# CITY OF ALBUQUERQUE

**RE: 2733 Candelaria Rd. NW**  
**Grading and Drainage Plan**  
**Engineer's Stamp Date: 10/14/2024**  
**Hydrology File: G12D044**

Richard Martinez, P.E.  
Senior Engineer, Hydrology  
Planning Department

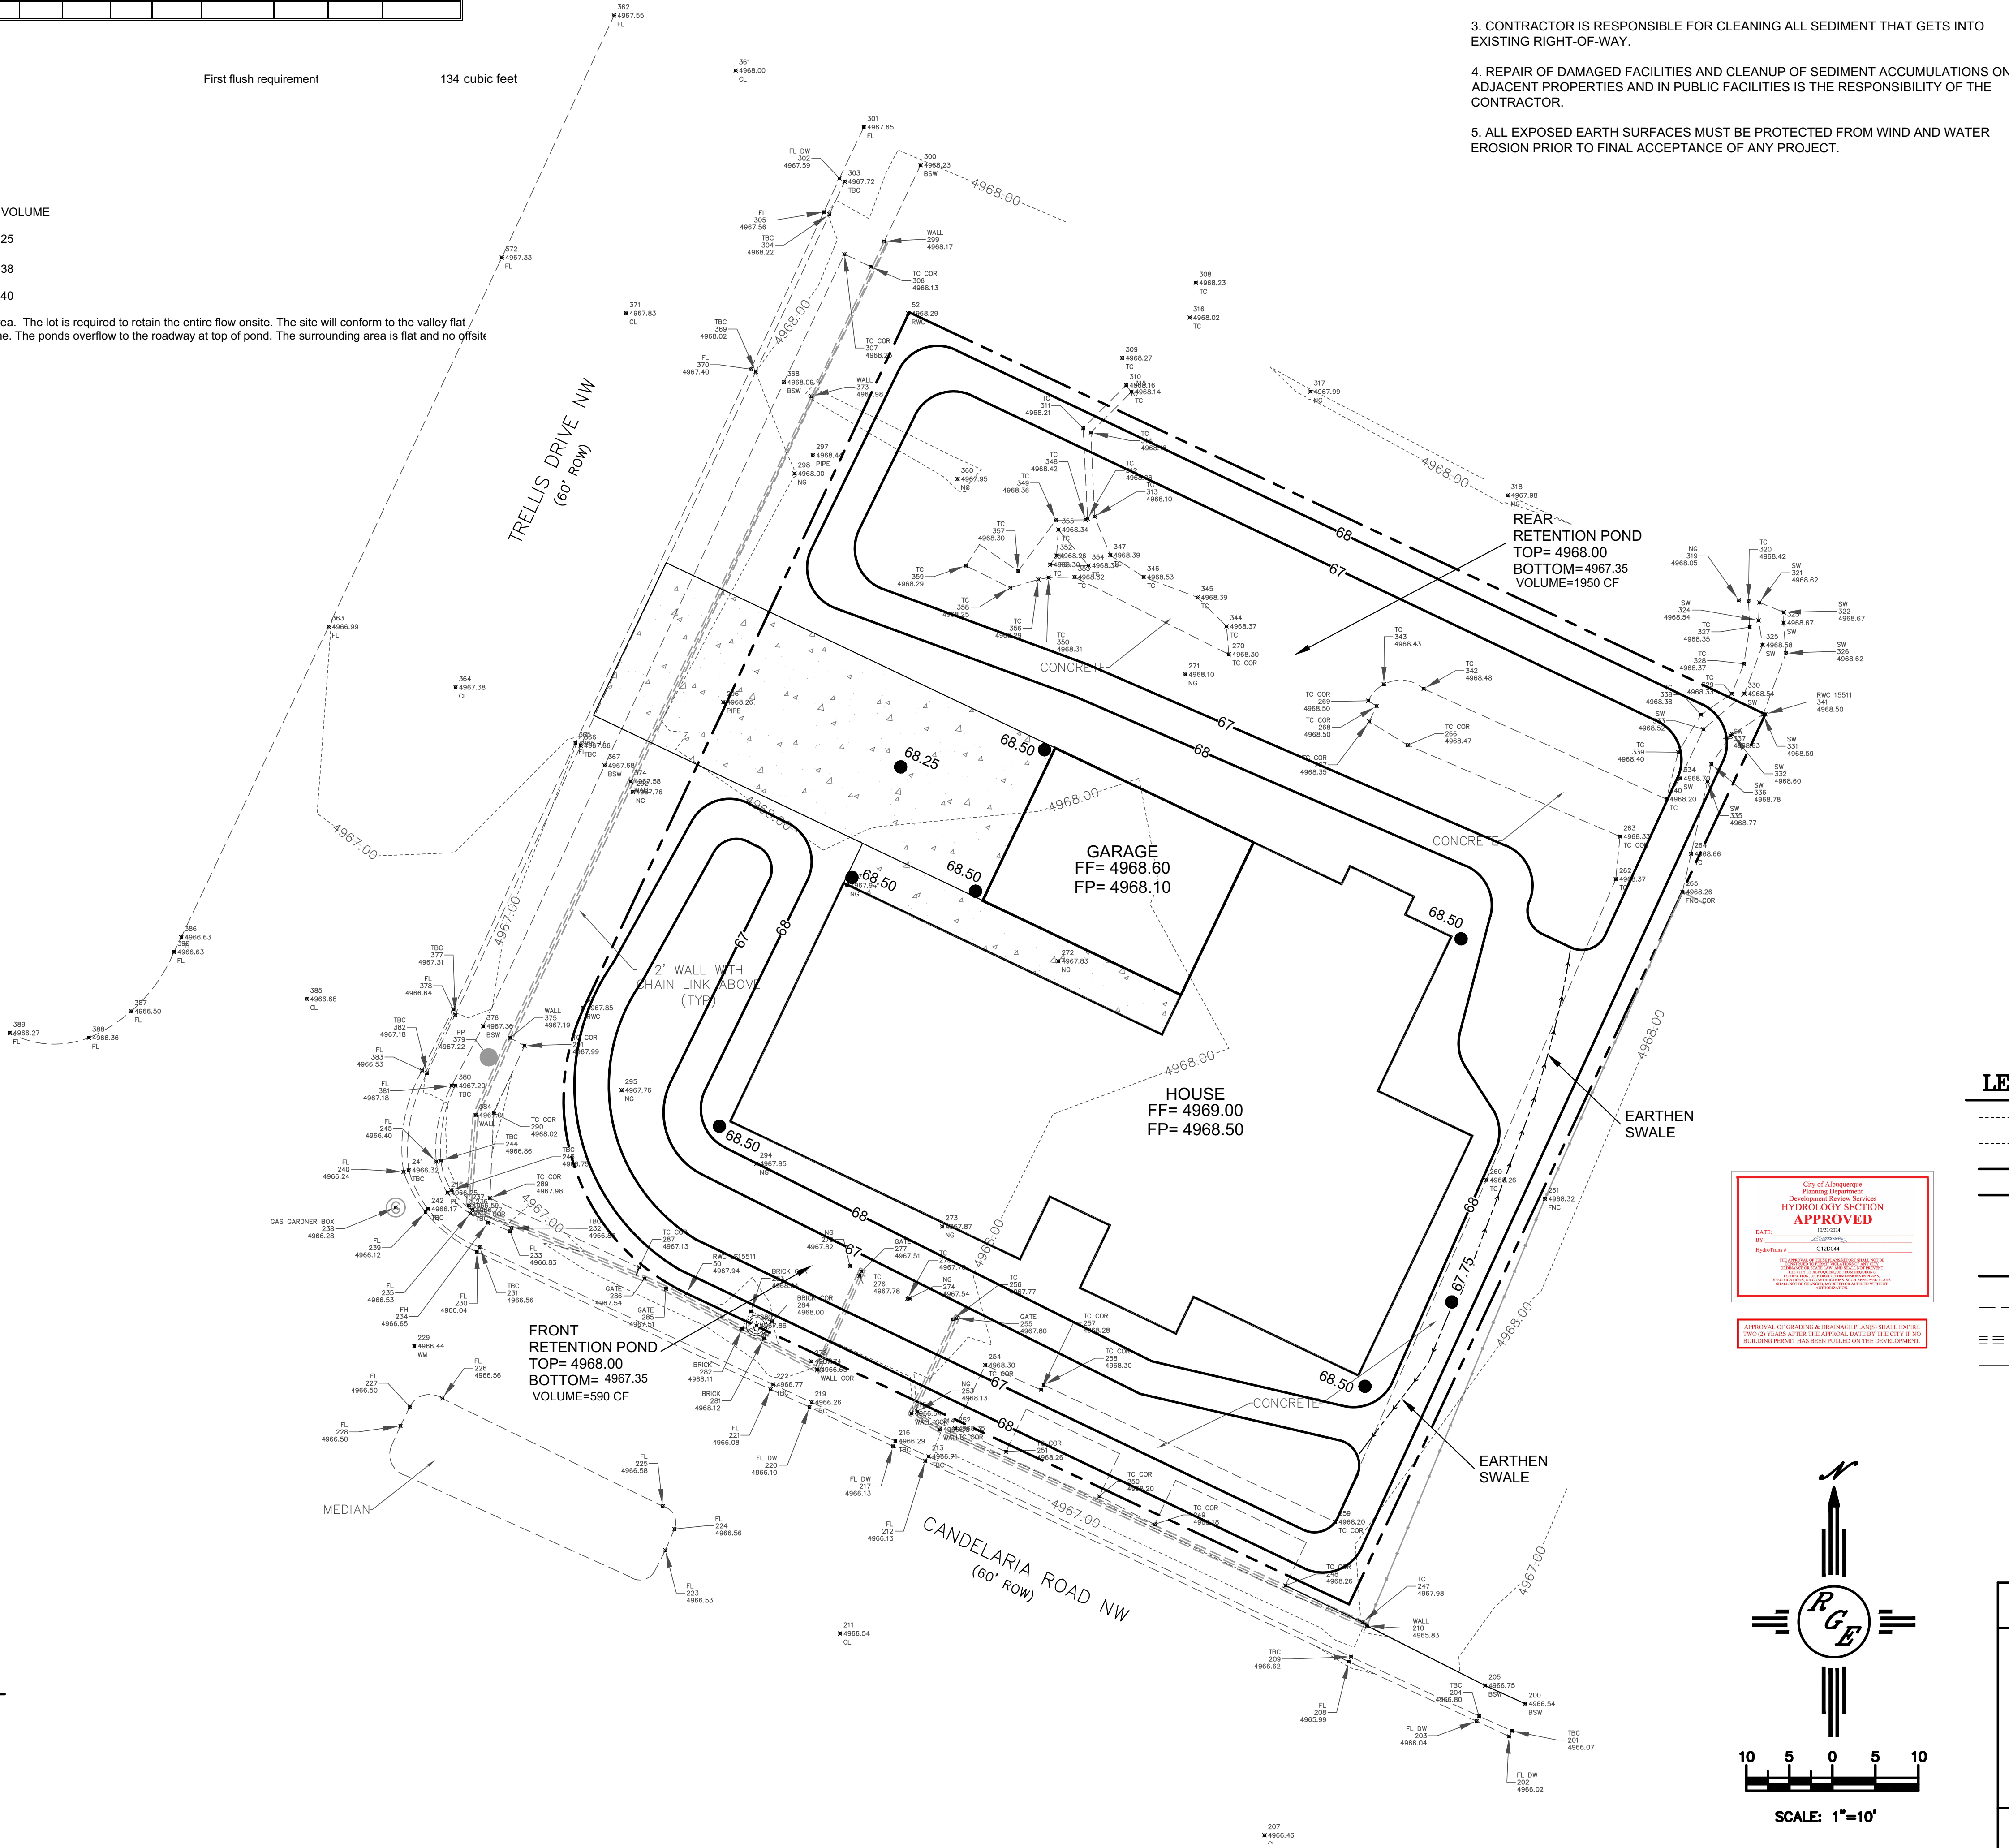
Based upon the information provided in your submittal received 10/15/2024, the Grading & Drainage Plan is approved for Building Permit and Grading Permit. Please attach a copy of this approved plan in the construction sets for Building Permit processing along with a copy of this letter.

1. Engineer's Certification, per the DPM Part 6-14 (F): *Engineer's Certification Checklist For Non-Subdivision* is required.

2. Please provide a Drainage Covenant with Exhibit A for the stormwater quality ponds per Article 6-15(C) of the DPM prior to Permanent Release of Occupancy. Submit the original copies along with the **\$25.00** recording fee check made payable to Bernalillo County to the Hydrology Section of Development Review Services on the Ground floor of Plaza de Sol.
